UNITED STATES
NUCLEAR REGULATORY COMMISSION
WASHINGTON, D.C. 20555-0001

SUBJECT: DRESDEN NUCLEAR POWER STATION, UNITS 2 AND 3 – STAFF
ASSESSMENT OF FLOOD HAZARD INTEGRATED ASSESSMENT
(CAC NOS. MG0221 AND MG0222; EPID L-2017-JLD-0050)

STAFF ASSESSMENT BY THE OFFICE OF NUCLEAR REACTOR REGULATION
RELATED TO THE INTEGRATED ASSESSMENT
FOR DRESDEN NUCLEAR POWER STATION, UNITS 2 AND 3
AS A RESULT OF THE REEVALUATED FLOODING HAZARD
NEAR-TERM TASK FORCE RECOMMENDATION 2.1 - FLOODING
CAC NOS. MG0221 AND MG0222, EPID L-2017-JLD-0050

Figure 3.3.5-1 Rating Curves at the Dresden Site.

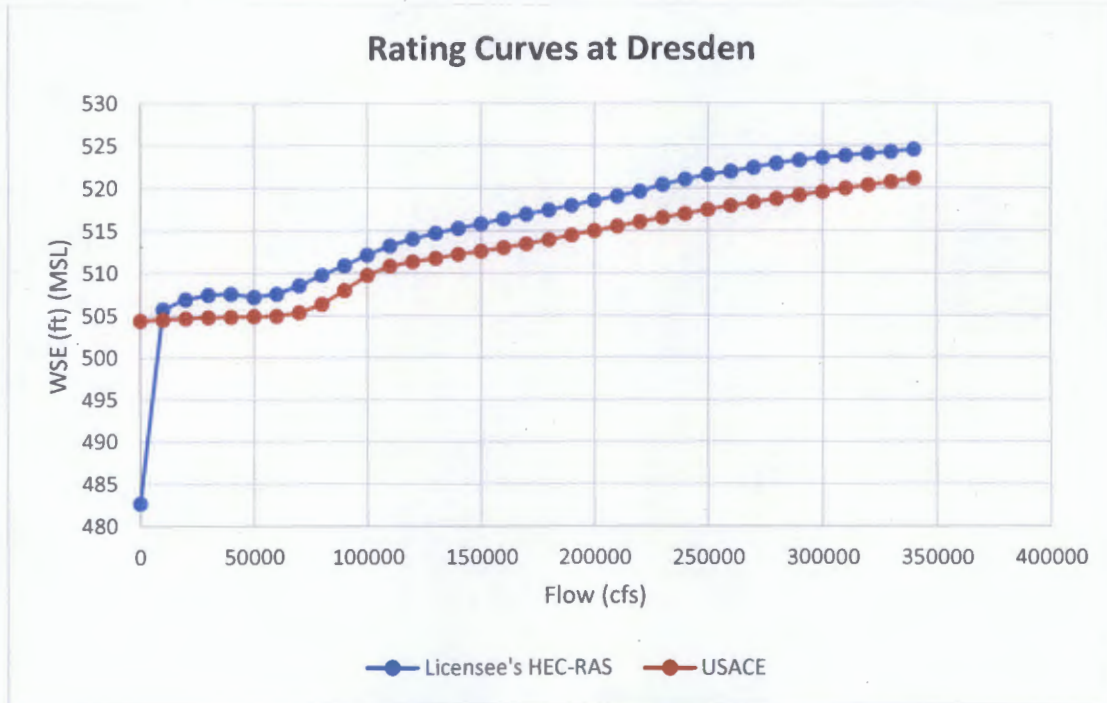
The staff generated a rating curve using the licensee's HEC-RAS model and compared this curve to the rating curve from flood frequency studies performed by the USACE for the region⁴. The NRC staff found the curve generated from the licensee's HEC-RAS model to be appropriate for use in the staff's independent analysis. The NRC staff used flow rates from the modified HEC-HMS models along with this rating curve to estimate the flood elevations for each scenario (Figure 3.3.5-1).
